STAFF RECOMMENDATION

C. Kelly
NCPC File No. 7094

FORT BELVOIR – NORTH POST NATIONAL MUSEUM OF THE UNITED STATES ARMY

June 30, 2011

Proposed Parking Layout

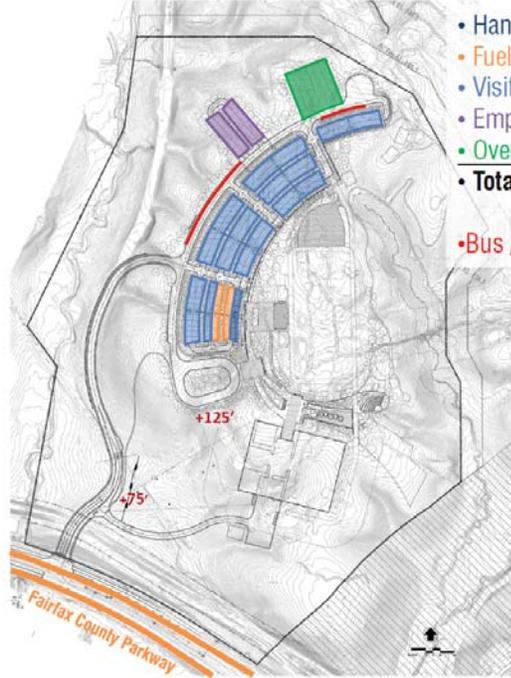
- **Reconfiguring or redesigning the parking lot in order to minimize impervious surfaces.**

The Army has reduced the amount of impervious surface on site from concept design; however, the surface area dedicated to parking and roadway is approximately 13 acres and given that the current site is a golf course and entirely pervious, we encourage the Army to continue to evaluate reducing the amount of impervious surfaces on site to the maximum extent possible. Staff does commend the Army for the use of bioswales and landscaping in the parking lot design; however, without stormwater calculations we are unable to determine if the proposed stormwater management will meet all stormwater requirements of Energy Independence and Security Act Section 438. We, therefore, recommend the Army evaluate the use of permeable concrete for the parking area and walkways as the Army proposed in the Post Exchange project.

Preliminary Site Layout

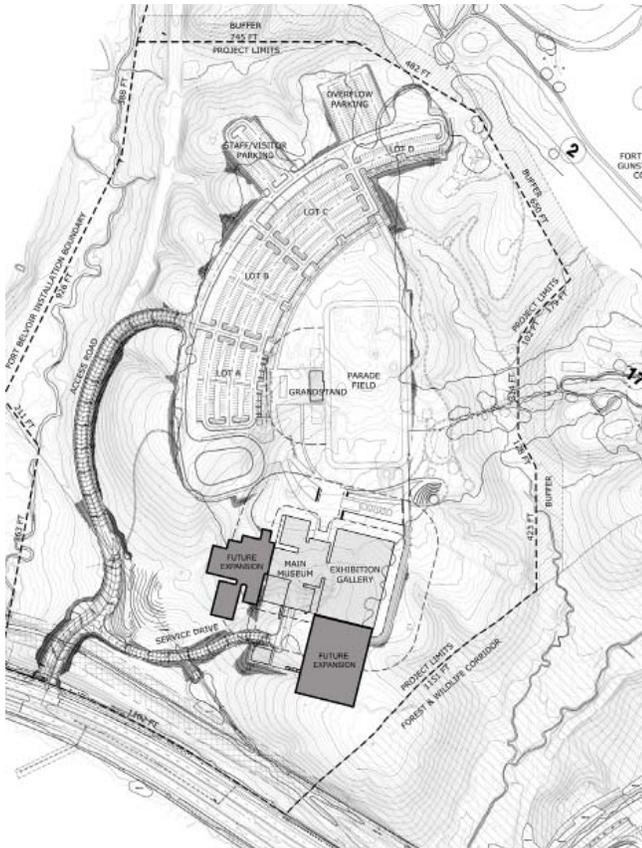
- **Opportunities for restoration, to a natural state, for the portion of Swank Road that is not being used to access the project site;**

With the redesign of the access road to a shorter road, the remainder of Swank Road is unused. We encourage the Army evaluate returning Swank Road to a natural state as part of the scope for the Museum project. The removal of the access road in this location provides the opportunity to restore this part of the site back to natural conditions, allowing for increase tree canopy and vegetation.

- **An architectural or sculptural element at the end of the entrance drive aisle to provide a focal point;**

Currently, the access road rounds the corner from the alignment of Swank Road and climbs the hillside to reach the project located on the plateau. Once one rounds the corner, a visitor finds the parking for the Museum. An architectural or sculptural element and the end of the entrance drive will provide the visitor a focal as they round the corner.

- **Pedestrian amenities, such as seating, along the walkway adjacent to the parade field;**

Due to the configuration of the parking, designed to keep all the parking on the plateau and not spill over to the hillside, a visitor may have to park over a quarter mile (1,320 feet) from the Museum building. To accommodate visitors, the Army proposes to construct a walkway adjacent to the parking with intensive vegetation. We recommend that the Army evaluate the use pedestrian amenities, in particularly seating opportunities, for the walkway due to its length.

- **Additional landscaping to minimize erosion of the hillside;**

The Army proposes to selectively clear trees out of a two acre area of the hillside to allow visitors an “iconic” view of the building as they drive on the access road. Tree clearing in this area will also be required for utility construction. Staff is concerned that the selective clearing of trees in this area has the potential to cause erosion of the hillside and we encourage the Army to evaluate different vegetative options for this section of the hillside in an effort to provide additional tree canopy and minimize the potential for erosion.
